Access Compliance Report Public Rights-of-Way (Curb Ramps)

Main Street: WINDMILL_AVE Cross Street: ANTONIO_PKWY Location: S

ADA ID: RPRK211029141456 Ramp Type: Type 1 - Perpendicular Diagonal Initial Pass/Fail: Fail Overall Compliance: No Severity Score: 0

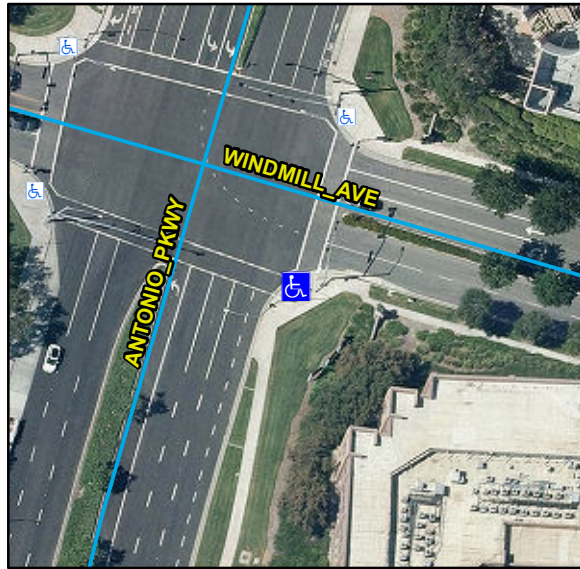
R304.2.2, R204.3, STD 1115

Remove & Replace Curb Ramp With Two New Directional Ramps or Equivalent.
